NOSE HILL DRIVE / STONEY TRAIL INTERCHANGE Functional Review

PRESENTATION To Scenic Acres Community Association

June 16, 2011

PROFILE COMPARISON NOSE HILL UNDER

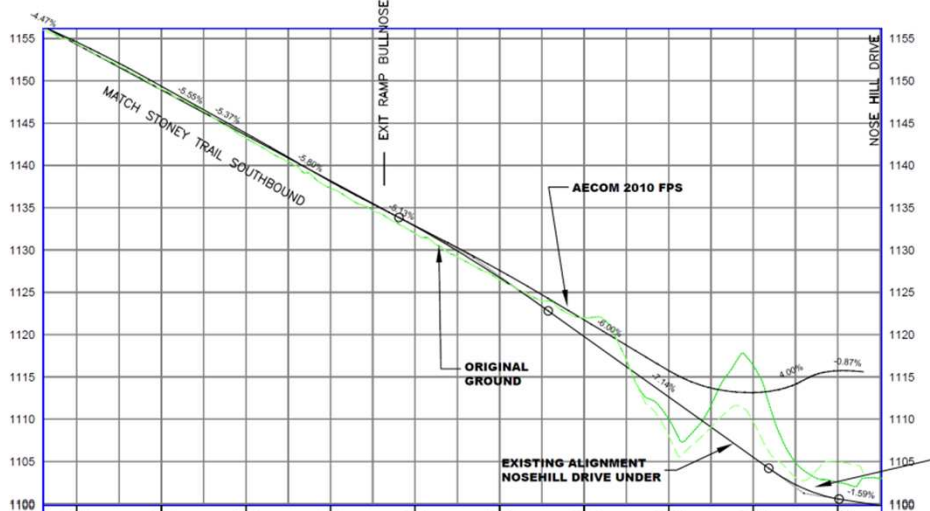
- Nose Hill Over along proposed 2010 alignment.
 compared with
- Nose Hill Under along existing roadway alignment.

PROFILE COMPARISON SOUTHBOUND OFF-RAMP

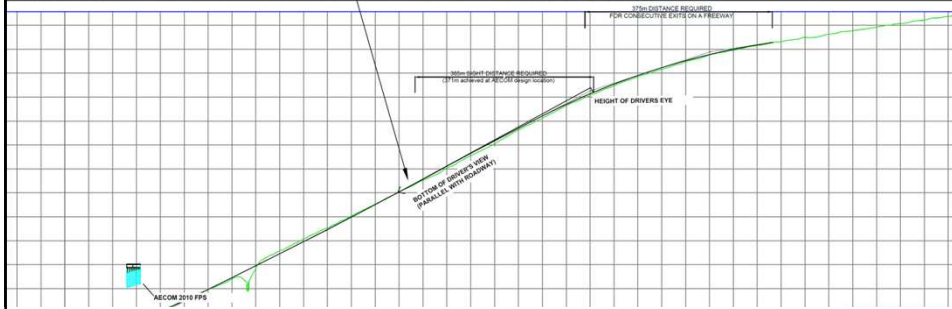
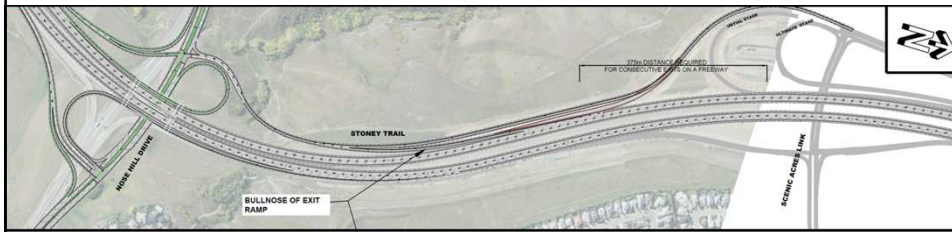
- The steeper grade (7.1%) and no sag approaching Nose Hill Drive ramp terminal intersection is a safety issue compared with proposed 2010 design.

RELOCATE SOUTHBOUND EXIT POINT

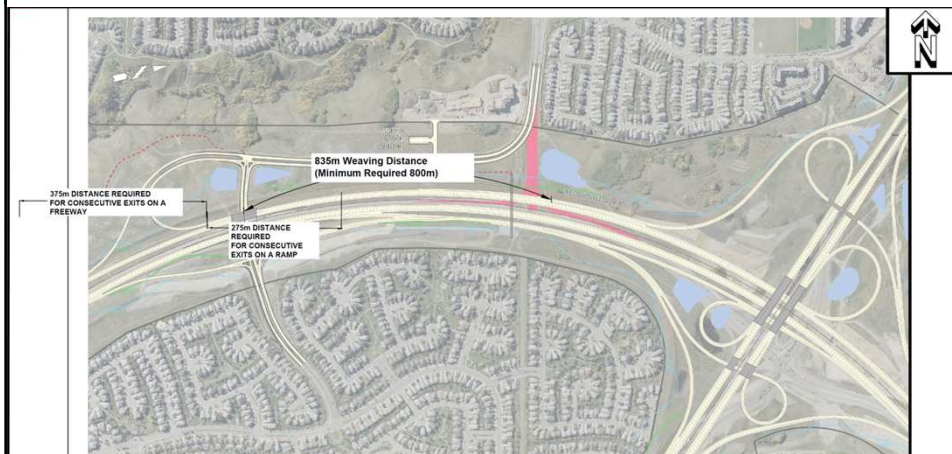
- Current exit point provides the required sight distance for driver.
- Minimum 375m spacing between consecutive exits prevents relocating crest near the Scenic Acres first stage - exit to loop ramp.

RELOCATE SOUTHBOUND EXIT POINT

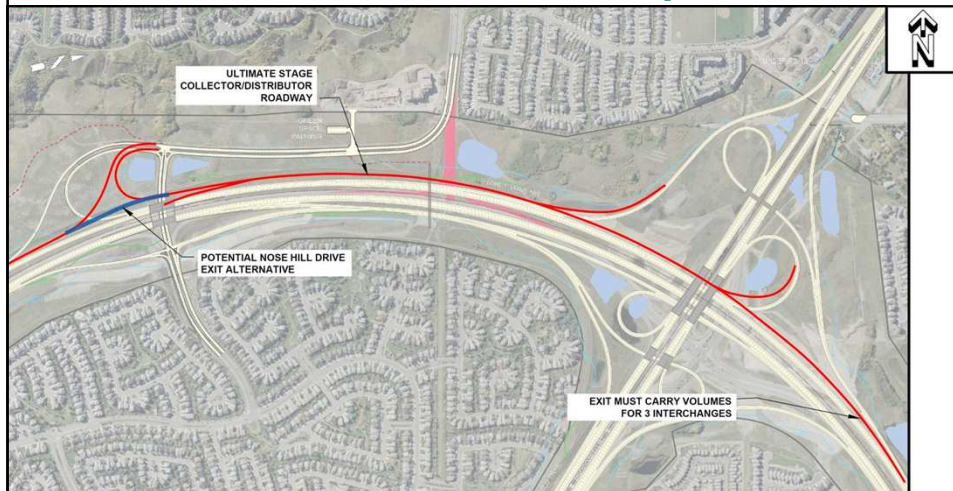
- Minimum 375m spacing between consecutive exits prevents relocating beyond crest near the Scenic Acres first stage - exit to loop ramp.
- Minimum 800m weaving distance between Crowchild and Scenic Acres prevents moving Scenic Acres exit 275m north along Stoney Trail for single exit point serving both NHD and Scenic Acres interchanges.

CONNECT NHD EXIT TO C/D ROAD

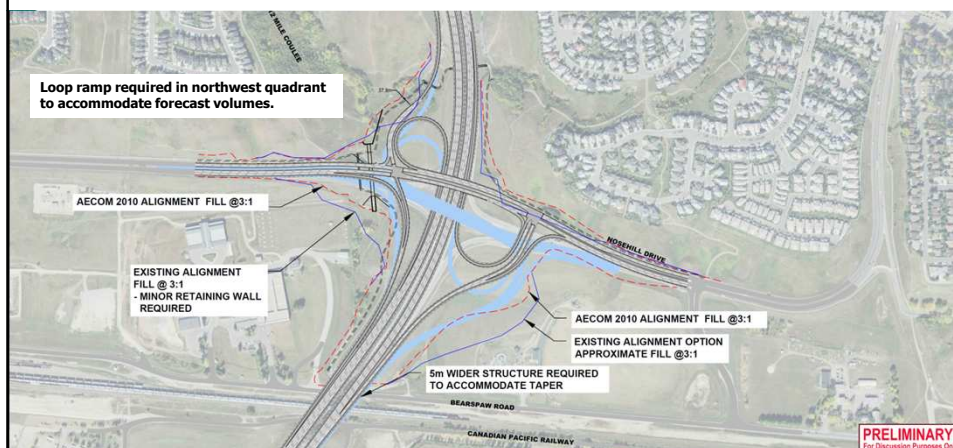
- No acceptable first stage solution.
- Would require building the ultimate C/D road immediately.
- Single exit point upstream of Crowchild Trail would require the C/D road to carry the exiting volumes for 3 interchanges. Significant cost increment.

NOSE HILL OVER - EXISTING ALIGNMENT

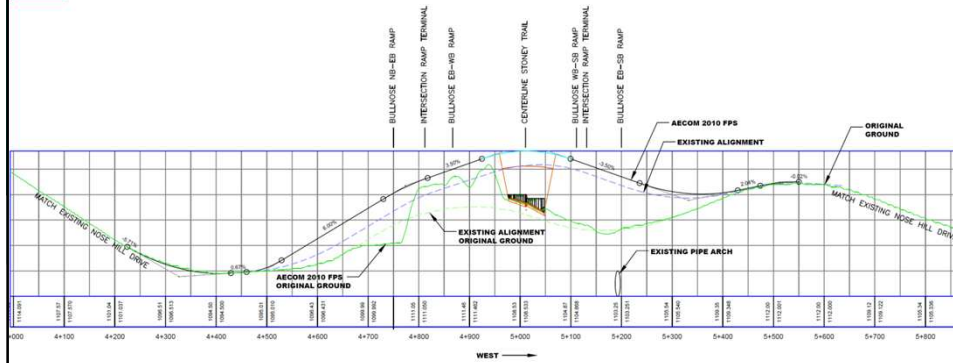
Existing Alignment requires:

- Minor retaining wall around water treatment plant.
- 5m additional widening of CP Rail structure.
- Less desirable geometry along NHD with poor integration of horizontal and vertical alignment; less utilization of existing terrain; higher grading costs.

PROFILE COMPARISON NOSE HILL OVER

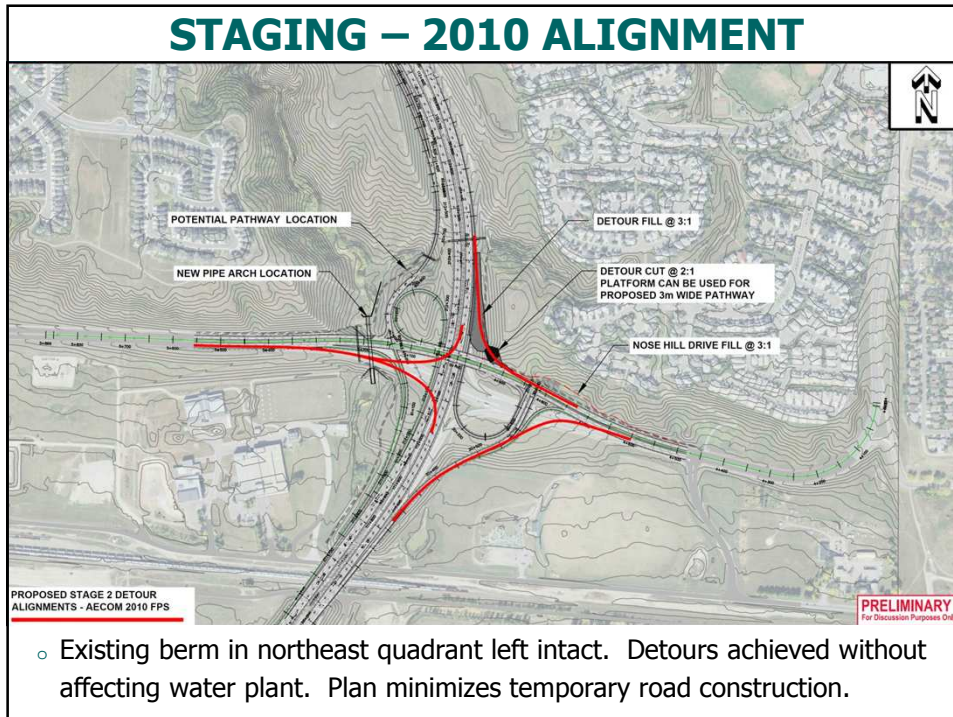
- o Nose Hill Over along proposed 2010 alignment compared with
- o Nose Hill Over along existing roadway alignment.

STAGING – 2010 ALIGNMENT

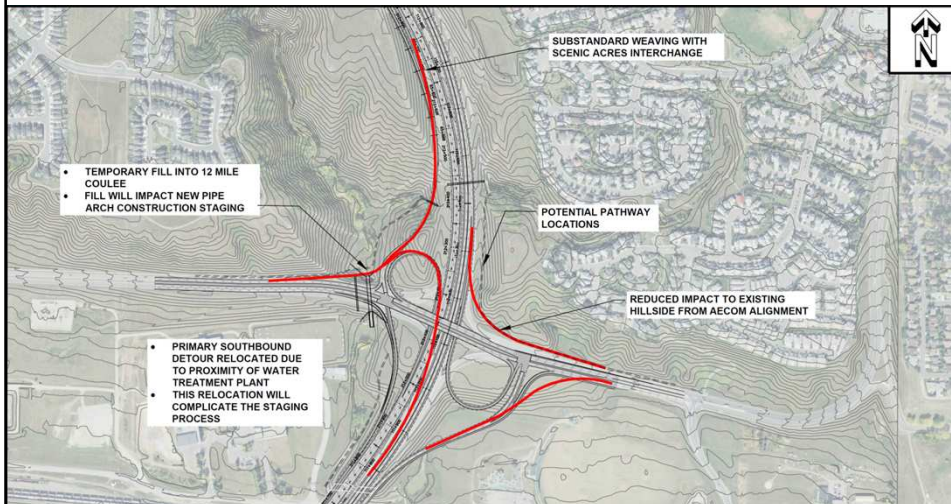
- o Existing berm in northeast quadrant left intact. Detours achieved without affecting water plant. Plan minimizes temporary road construction.

NOISE ANALYSIS

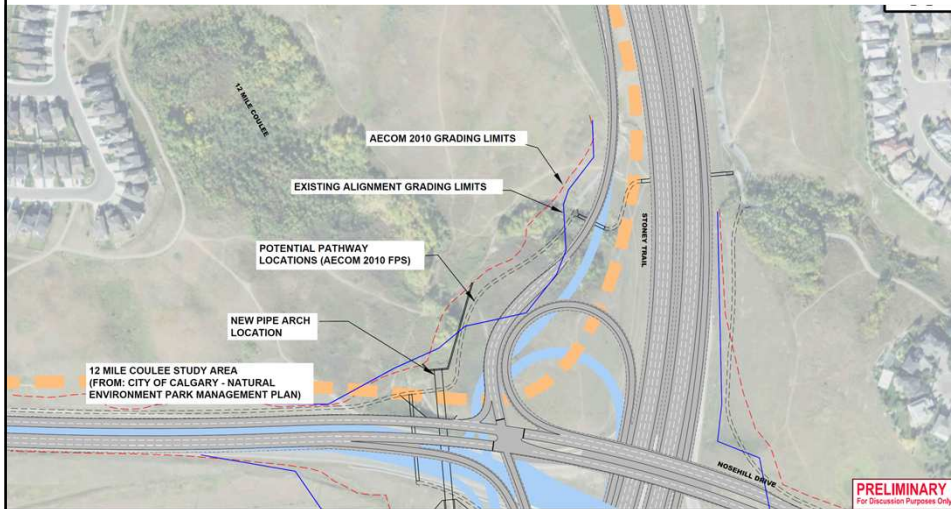
- ACI was retained to conduct a noise assessment comparing the two NHD alignments.
- NHD evaluated with 8% (existing) and 12% heavy trucks (typically 5%) to test sensitivity.
- Increase due to truck percentage ranged between 0 and 0.7 dBA, subjectively imperceptible.
- Largest difference between the two alignments was 2.1 dBA, (at the lower range of being subjectively perceptible) occurring along NHD away from Stoney Trail.
- All results projected to be well below Alberta Transportation's warrant for noise attenuation; 65 dBA $L_{eq}24$.
- Results for 12% trucks reached 60 dBA for 2010 alignment and 58 dBA for existing alignment.

INCREMENTAL ENVIRONMENTAL FOOTPRINT

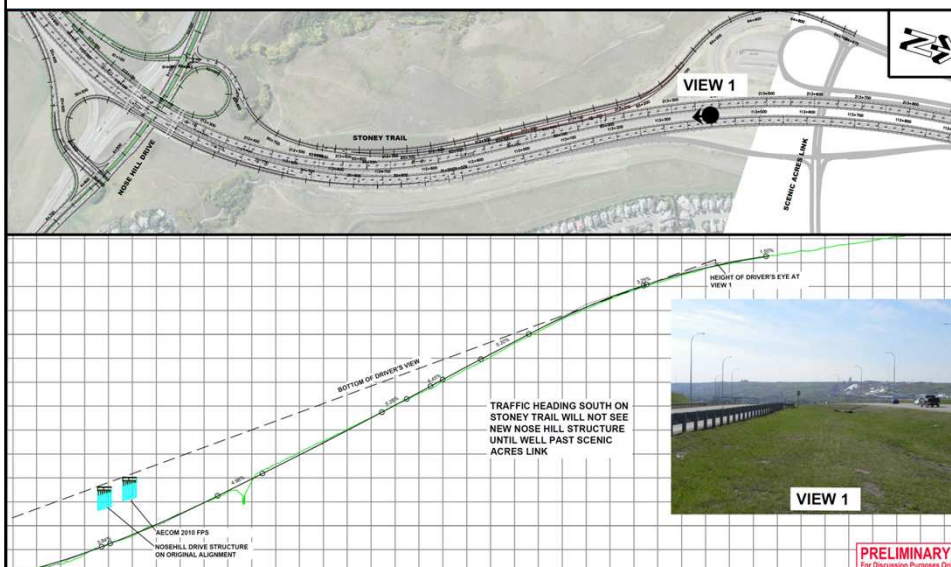
- o Grading limits in northwest quadrant are shown for both interchange plans.
- o 2010 NHD alignment requires approximately 0.45 additional ha.
- o It is noted that the 2010 plan was determined in consultation with the City of Calgary and has required regulatory approvals.

SIGHTLINES – STONEY TRAIL - 3

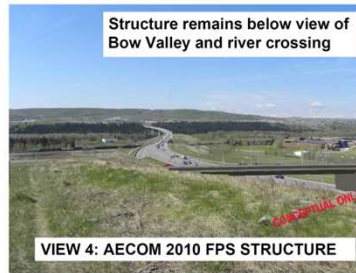
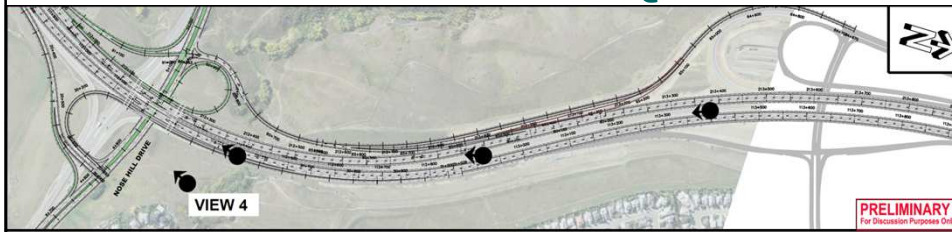
- The overpass structure is a preferred outcome for driver expectations, better alerting the driver to pending exit, entrance and weaving manoeuvres, particularly on a horizontal curve.

SIGHTLINES – NORTHEAST QUADRANT - 4

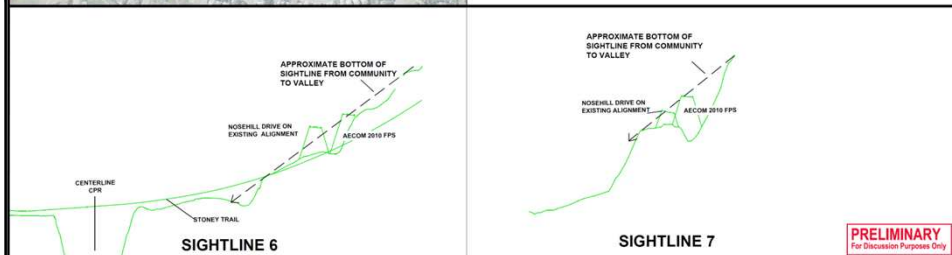
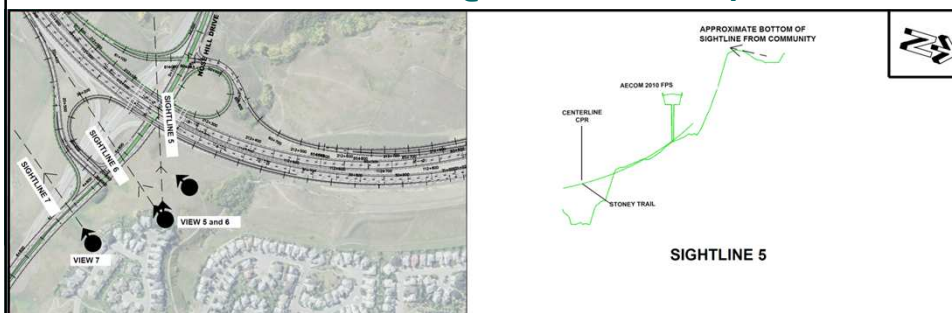
- From a vantage point below the Scenic Acres homes, the structure remains below the view of the Bow Valley and river crossing.
